Tangmere

Overheating Report

Technical Note

This Technical Note has been drafted as a supplementary document to the submitted report (ref: CS2895/T/OH/202607-JT) issued by NRG Consulting with respect to **Planning Condition 48a Tangmere, Broadwater Farm, N17**. This note is intended to provide additional information following comments raised by the Local Authority during determination.

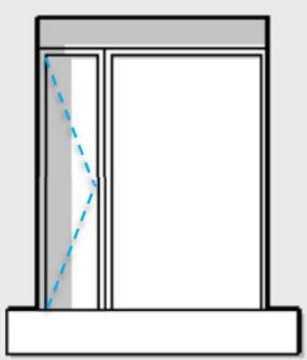
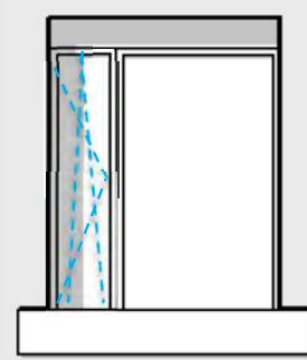
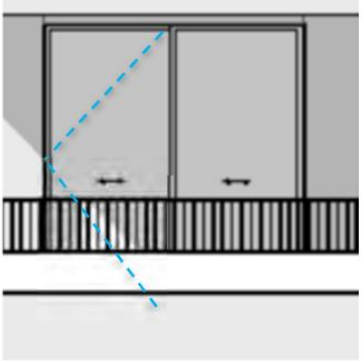
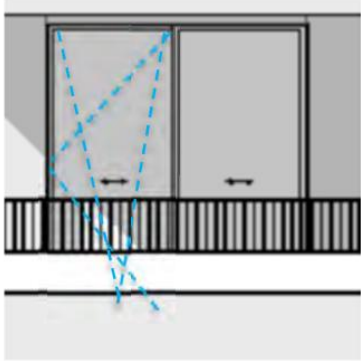
The refrigerant charge of the units is negligible (350g maximum) so overall GWP impact is still very low.
Please confirm if only the units listed under section 5.4 will be installed with MVHR comfort cooling. What is the number of units in total supplied with MVHR cooling and percentage in relation to the total number of units in phase 2?	This is confirmed. MVHR cooling is being supplied to 52 / 139 units i.e. 37%.
Please confirm the ventilation method of the communal corridor to achieve the air exchange rate of 0.93 ACH.	The corridors are naturally ventilated. This figure has been removed in Rev. B of the report and our modelling now only reflects the buildings passive air infiltration and naturally occurring ventilation through pedestrian movement only.
One of the proposed retrofit measures depends on the increasing the window opening angle. Applicant should clarify if this would go against the acoustic advice.	It would not go against acoustic advice <i>per se</i>, it would just be against the recommendations of Part O modelling. As there are no physical restrictors being installed, should there be increased temperatures, it is reasonable to assume the residents would open windows further if the outside air was providing a benefit in cooling their home. The facades here are only marginally above the Part O noise levels (hence the <i>orange</i> and <i>yellow</i> elevations rather
